Model: Finisher for the AD3		Date: 31-July-97	No: 1
Subject: ROM modification for Main Control Board		Prepared by: E. Fukuyama	
From: QAC 2nd Field Information Dept.			
Classification:	<input type="checkbox"/> Troubleshooting	<input type="checkbox"/> Part information	<input type="checkbox"/> Action required
	<input type="checkbox"/> Mechanical	<input type="checkbox"/> Electrical	<input type="checkbox"/> Service manual revision
	<input type="checkbox"/> Paper path	<input type="checkbox"/> Transmit/receive	<input type="checkbox"/> Retrofit information
	<input type="checkbox"/> Other ()

Model: Finisher for the AD3		Date: 30-Sep-97	No: 18
Subject: SC101		Prepared by: E.Fukuyama	
From: QAC 2nd Field Information Dept.			
Classification:	<input checked="" type="checkbox"/> Troubleshooting	<input type="checkbox"/> Part information	<input type="checkbox"/> Action required
	<input type="checkbox"/> Mechanical	<input type="checkbox"/> Electrical	<input type="checkbox"/> Service manual revision
	<input type="checkbox"/> Paper path	<input type="checkbox"/> Transmit/receive	<input type="checkbox"/> Retrofit information
	<input type="checkbox"/> Other ()

Entrance Guide Installation Procedure

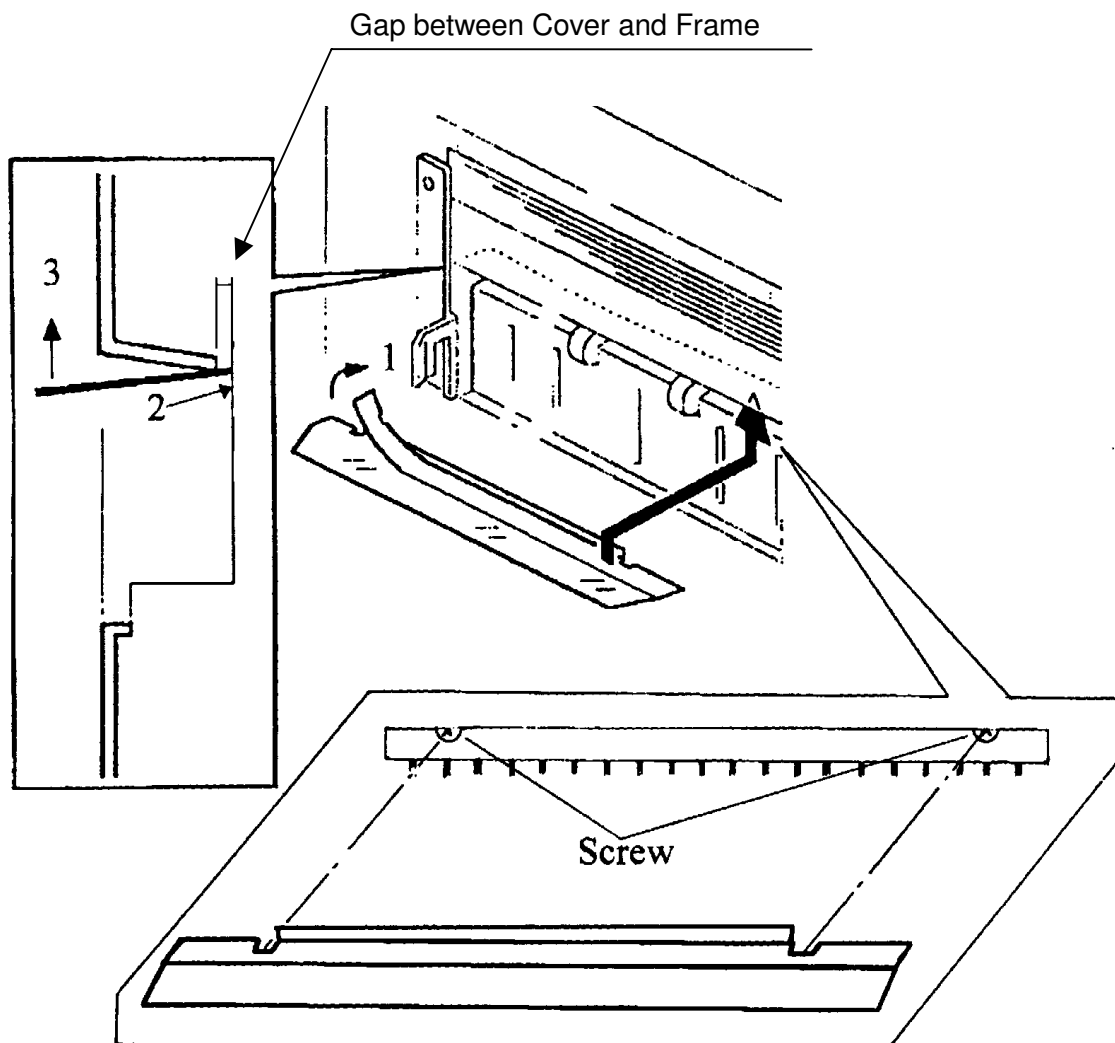
For the machines on which the Finisher is installed, if a large amount of copies is made right after power-up, SC101 may occur. If SC101 occurs, please replace the Entrance Guide with part number A6122333. The installation procedure for the Entrance Guide is shown on the next page.

If the Entrance Guide is not installed in the proper position, a gap may develop between the Cover and the Main Frame through which the heat and humidity generated by the paper may enter and lead to high temperature/high humidity around the lamp stabilizer.

During the set-up of a Finisher manufactured after May 1997, please install the Entrance Guide in a manner that will prevent a gap from developing between the Cover and the Main Frame. Please refer to the attached page for this procedure.

In the event of an SC101 on a Finisher manufactured before April 1997, please replace the Entrance Guide with part number A6122333.

1. Peel off the tape seal for the Entrance Guide
2. Place the Entrance Guide on the Main Frame.
3. Attach the Entrance Guide to the Cover

New Entrance Guide
